TOWN OF WILTON
ADDENDUM NO. 2

RFP #2022-09

**Request for Proposal to Replace Lovers
Lane Bridge - Bridge #04975**

ADDENDUM NO. 2

DRAWING NO. S-13
 SHEET NO. 04.13.A2

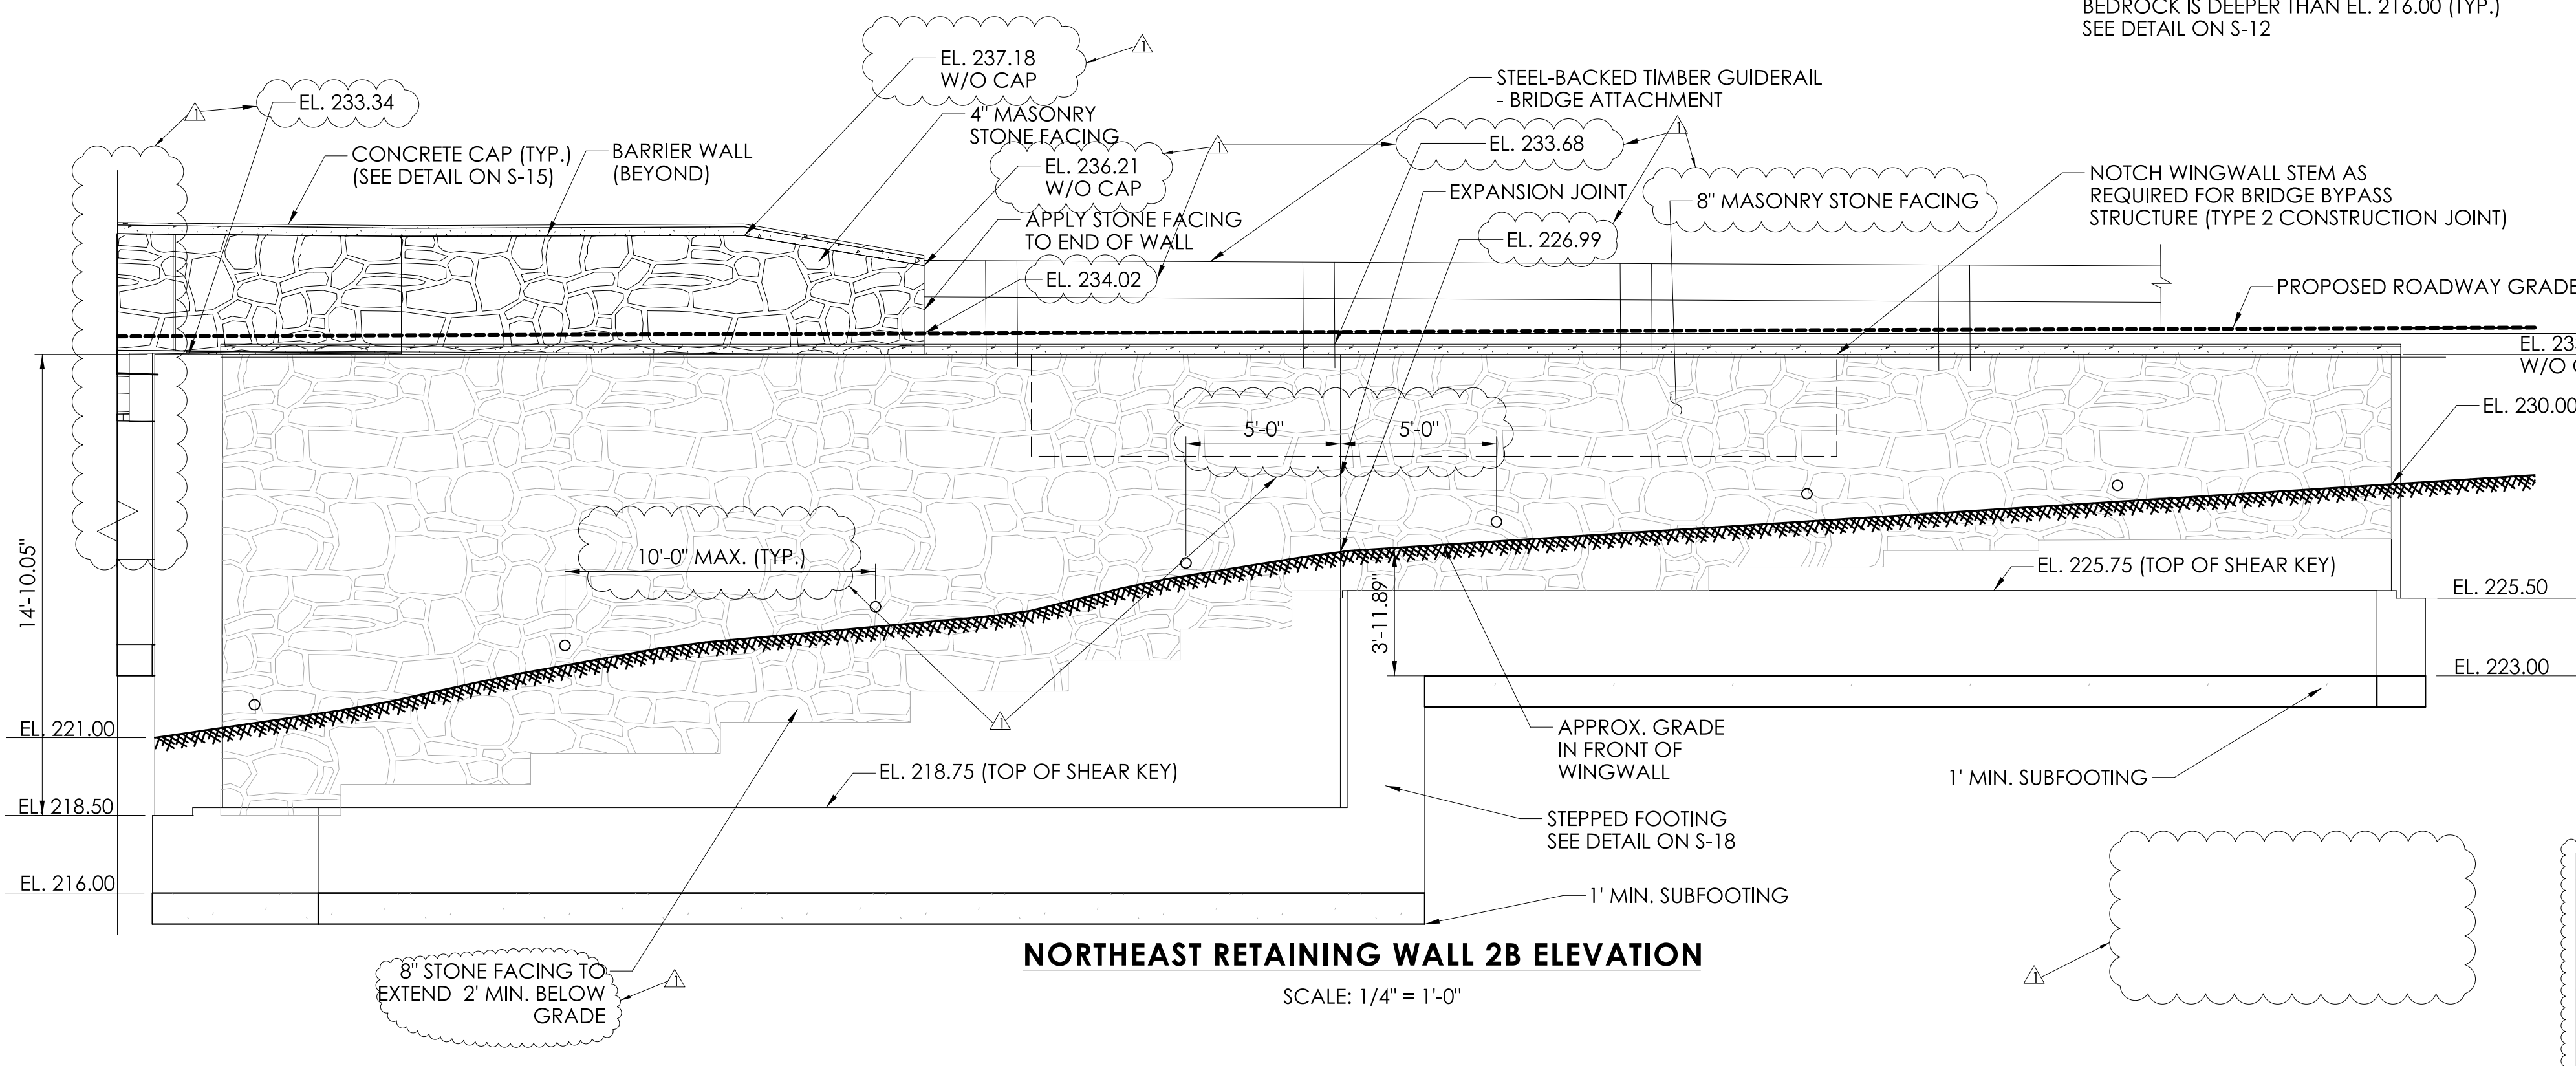
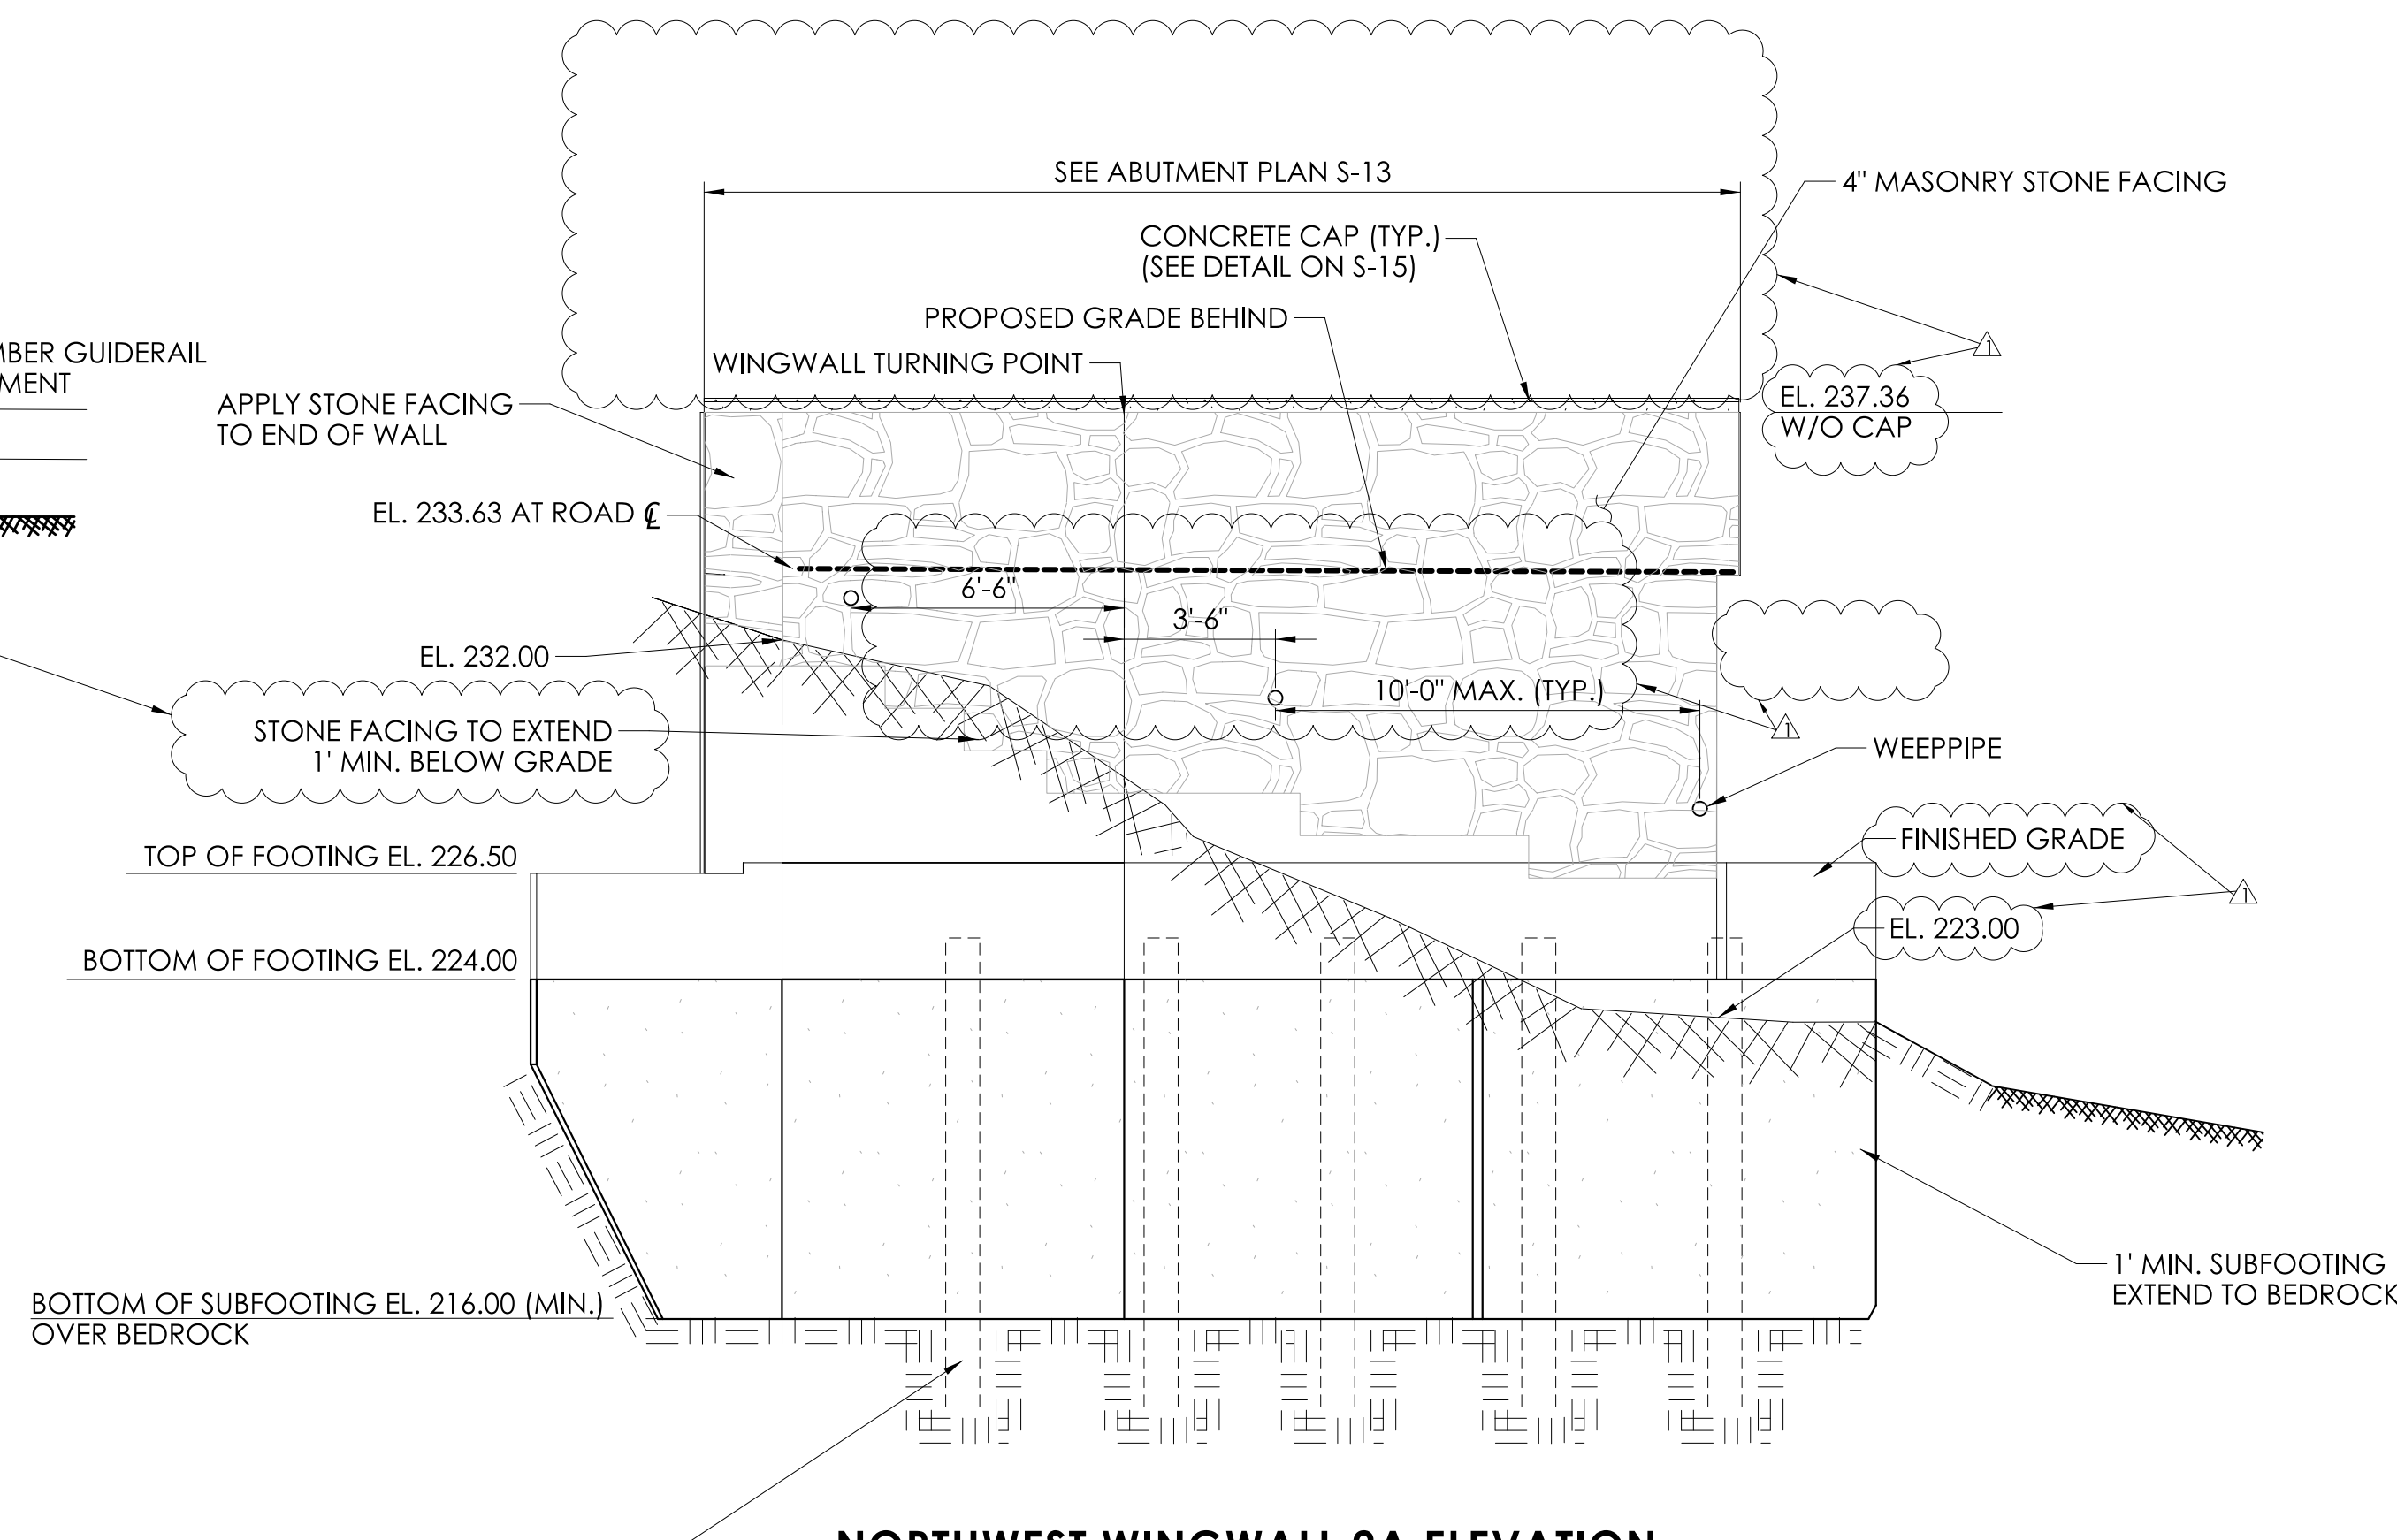
REV.	DATE	REVISION DESCRIPTION
1	12/15/22	REVISE WINGWALLS
